Village of Itasca

Committee of the Whole Meeting Agenda June 21, 2016

TO: Village President Jeff Pruyn and Itasca Board of Trustees
FROM: Nancy Hill, Community Development Director
DATE: June 16, 2016 for June 21, 2016 Village Board COW Meeting
RE: Relief from Building Code for 400 E. Walnut Street (Itasca County Club)

Subject: Village of Itasca/Illinois Tollway/IDOT/DuPage County/Township of Addison
Intergovernmental Agreement (IGA)
Illinois Route 390 Hamilton Lakes Drive to Arlington Heights Road
Recommendation for Execution of Cost Participation Letter (with conditions)

- POOL DECK & SNACK SHACK MODIFICATIONS -

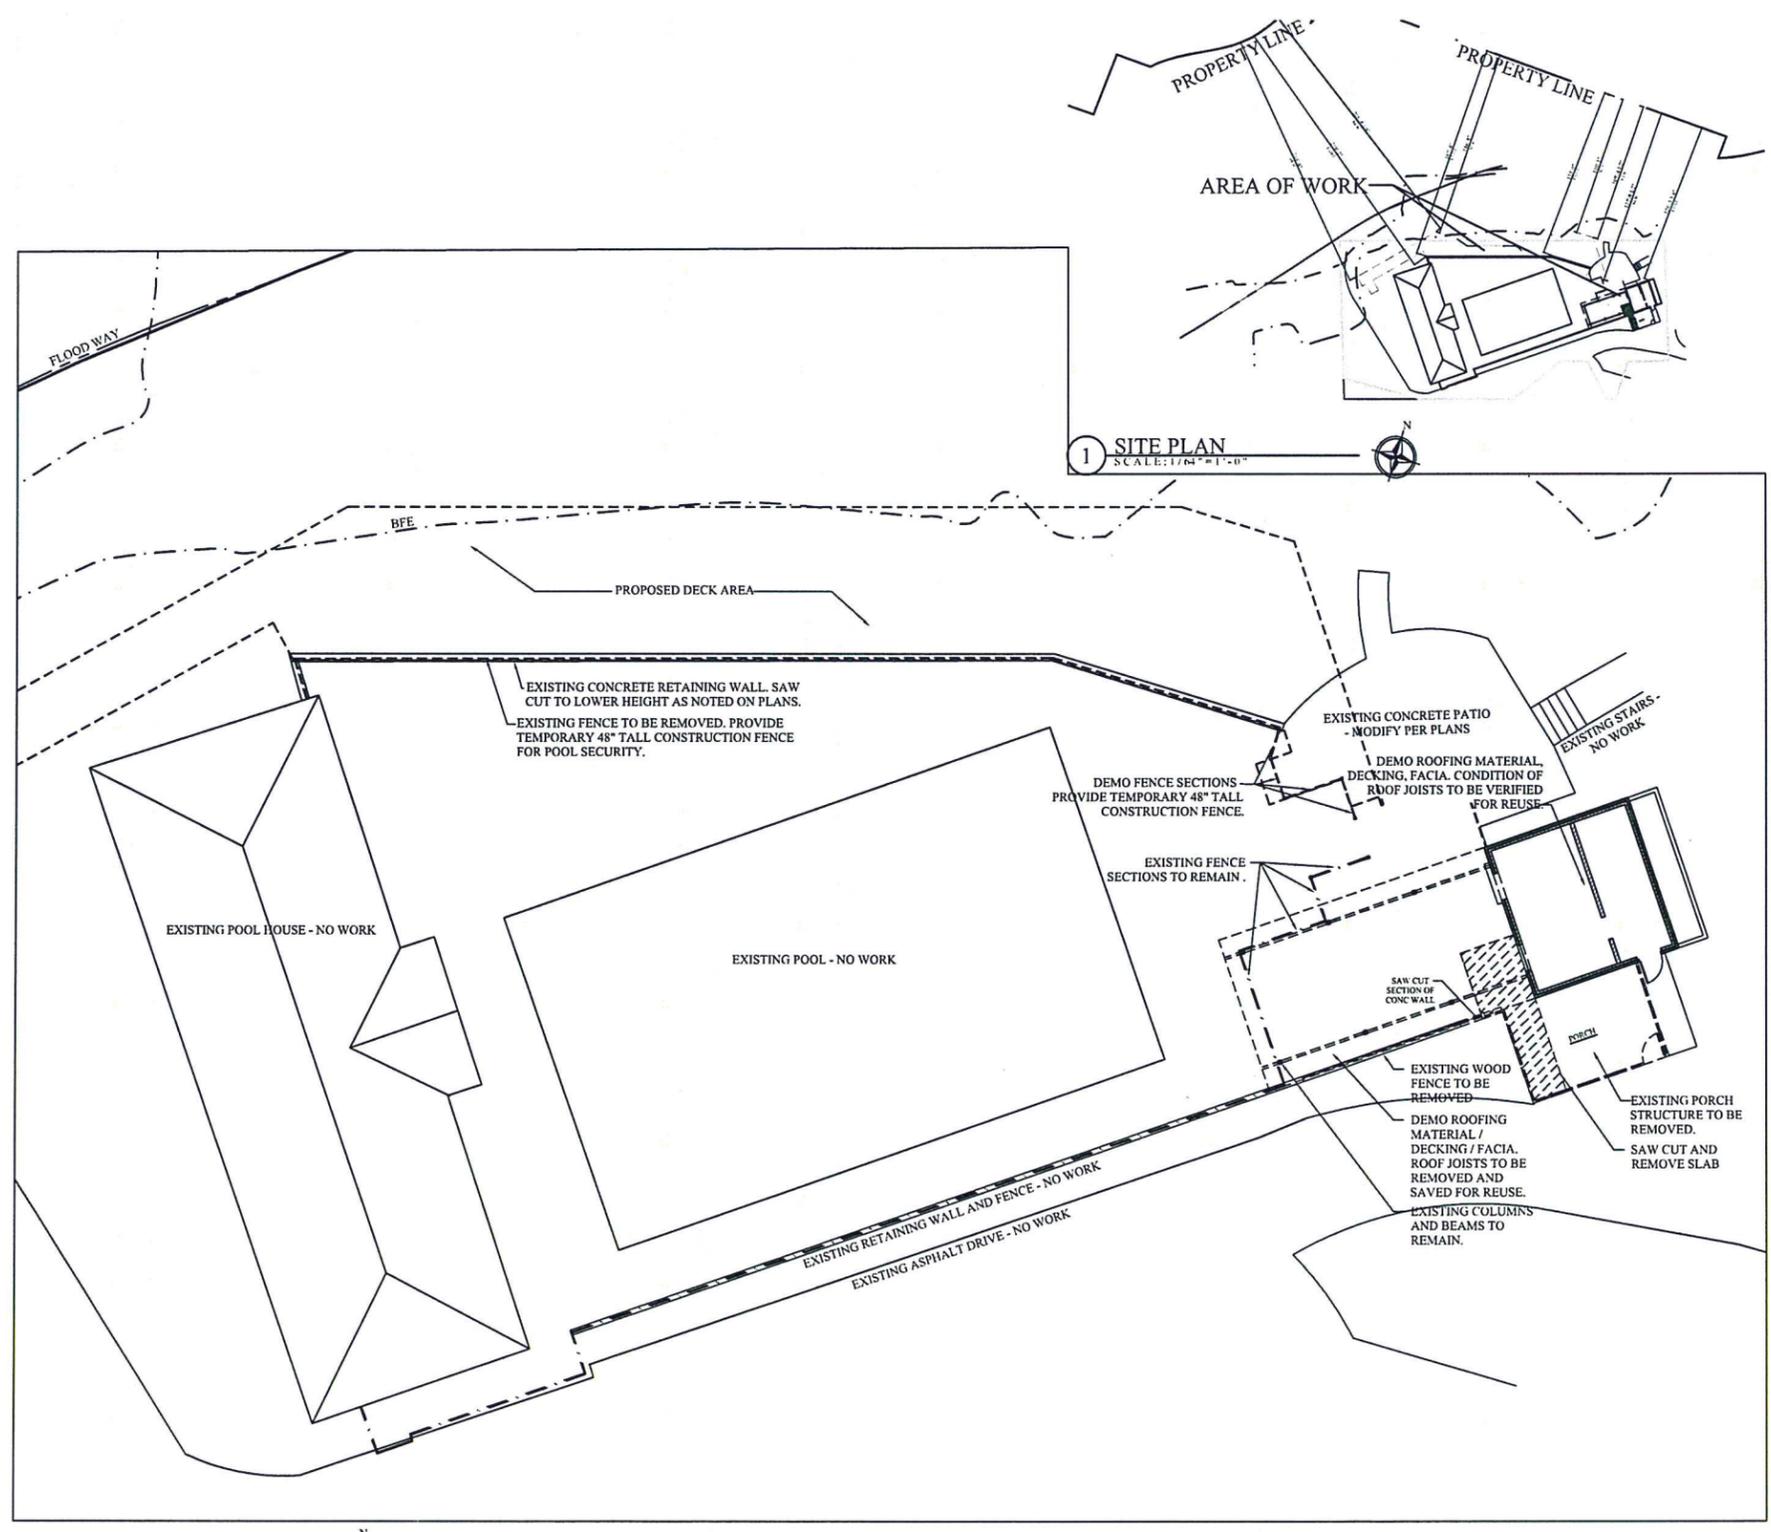
The Itasca Country Club is requesting relief from the Building Code for the installation of a new deck around the pool and snack stand.

The Building Code Amendments requires that the proposed deck be constructed out of non-combustible materials because of where the deck is located and because it is secured an existing masonry structure. The local Building Code amendments prohibits Type V combustible construction, which is usually treated wood. An acceptable construction material, under the Code amendments, would be fire retardant wood or any non-combustible material. However, fire retardant wood is generally not available for deck floor construction, and if it is available, it is not available at a reasonable cost.

We kindly request to use treated wood instead of fire retardant wood on our pool deck and snack stand as indicated on the attached drawings and as submitted to the Community Development Department for Permit 25110 & Permit 25112 for the Itasca Country Club.

Because the structures will be built adjacent to a cement patio and our swimming pool, we do not believe that the use of treated wood will cause a risk to public health. Given the increased cost of and the increased time to acquire fire retardant wood vs. treated wood, we ask for relief from the Village's adopted building codes to allow for use treated wood instead of fire retardant wood on our pool deck and snack stand.

Village staff and the Itasca Fire Protection District have reviewed this request for relief from the Building Code and recommend granting the relief from the Building Code for the deck surface, railings, and guard materials. We recommend the Itasca County Club use either non-combustible or fire-retardant treated materials for framing, including columns, joists, rafters, and roof decking. See also attached memo from Leigh Fabbri, Itasca Fire Protection District.

I move to approve the requested relief from the Building Code amendments to allow the proposed deck at 400 E. Orchard Street to be of combustible construction with the following conditions:

1. The combustible construction be for construction allowed by Building Permits #25110 and #25112 only.
2. The combustible construction be for the deck's surface, railing, and guard materials only.
3. Non-combustible or fire-retardant treated materials be used for the deck's framing including columns, joists, rafters, and roof decking.

The Itasca Fire Protection District recommends the Village of Itasca allow the applicant to use Type V for the deck surface, railing and guard materials. The applicant should use either non-combustible or fire-retardant treated materials for framing including columns, joists, rafters and roof decking.
